# UNITED STATES PATENT AND TRADEMARK OFFICE

APPLICATION NO.	FILING DATE	FIRST NAMED INVENTOR	ATTORNEY DOCKET NO.	CONFIRMATION NO.
10/689,001	10/20/2003	Gayatri Vyas	8540G-236COA	4101

## Office Action Summary

## **DETAILED ACTION**

FIG. 1

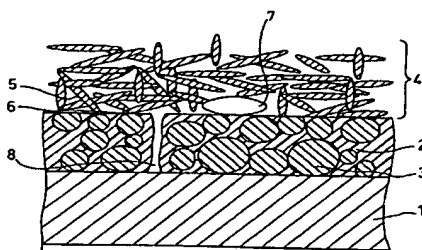
**1<sup>st</sup> approach:** it is imperative to note that the electroconductive resin layer incorporates therein an electroconductive particulate substance (COL 4, lines 5-15) and powders of metal oxide such as Ru-oxide are effective as the electroconductive particulate substance (COL 4, lines 15-21). As depicted in **Figure 1** below, electro-conductive particles 3 are dispersed in the electroconductive resin layer 2 and direct contact gas diffusion electrode 4 (See Figure 1/ COL 6, lines 12-30). Thus, Ru-metal oxide particles directly contact the electrode 4.

**2<sup>nd</sup> approach:** Additionally, there is embodied in **Embodied Example 6** having a metal oxide layer between the metal substrate and the resin layer (EMBODIED EXAMPLE 6, COL 8, lines 35-52). *The electrically conductive property of the metal oxide film is inherent to the composition itself.* Gyoten et al teach that the oxide layer is situated between the metal substrate 1 and said electroconductive resin layer 2 (COL 8, lines 48-52/CLAIM 2). Notice also the presence of pin-hole 8 and gas diffusion electrode 4 (See FIGURE 1/COL 6, lines 12-30). *Given that pin-hole 8 directly provides an open path therebetween, it can be said that reactant gas diffusing through gas diffusion electrode also diffuses through the electroconductive resin layer 2. Therefore, said reactant gas contacts or communicates with the oxide layer placed between the metal substrate 1 and said electroconductive resin layer 2.*

FIG. 1

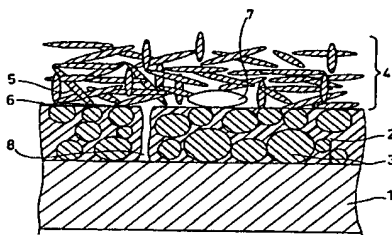
**1<sup>st</sup> approach:** in this respect, (*emphasis supplied*→) it is imperative to note that electroconductive resin layer 2 incorporates therein an electroconductive particulate substance (COL 4, lines 5-15) and powders of metal oxide such as Ru-oxide are effective as the electroconductive particulate substance (COL 4, lines 15-21). As depicted in **Figure 1** below, electro-conductive particles 3 are dispersed in the electroconductive resin layer 2 and direct contact gas diffusion electrode 4 (See Figure 1/Col 6, lines 12-30). Thus, Ru-metal oxide particles directly contact the electrode 4.

**2<sup>nd</sup> approach:** In addition to that, applicant has articulated that the reference “*fails to teach a metal oxide coating in communication with a reactant gas*”. Interestingly, applicant has admitted that “*The oxide layer, being sandwiched between the substrate and the resin layer, prevents contact between the oxide layer and the reactant gas*” (See amendment dated 11/03/06 at page 16, last sentence of 2<sup>nd</sup> full paragraph). This applicant's statement or admission

contributes to the position taken by the examiner because the oxide is formed on the surface of the metal substrate 1 facing the gas diffusion electrode 4. Accordingly, reactant gas diffuses through pinhole 8 in the resin layer 2 and contacts the oxide layer deposited between the resin layer 2 and the metal substrate 1. Since the oxide layer prevents contact between the reactant gas and the metal substrate, it can be said that the oxide layer is acting as a direct barrier therebetween. Meanwhile, the oxide layer per is in direct contact with the reactant gas, and therefore in communication therewith.

Stated alternatively, Gyoten et al teach that the oxide layer is situated between the metal substrate 1 and said electroconductive resin layer 2 (COL 8, lines 48-52/CLAIM 2). Notice also the presence of pin-hole 8 and gas diffusion electrode 4 (See FIGURE 1/COL 6, lines 12-30). Given that pin-hole 8 directly provides an open path therebetween, it can be said that reactant gas diffusing through gas diffusion electrode also diffuses through the electroconductive resin layer 2. Therefore, said reactant gas contacts or communicates with the oxide layer placed between the metal substrate 1 and said electroconductive resin layer 2.
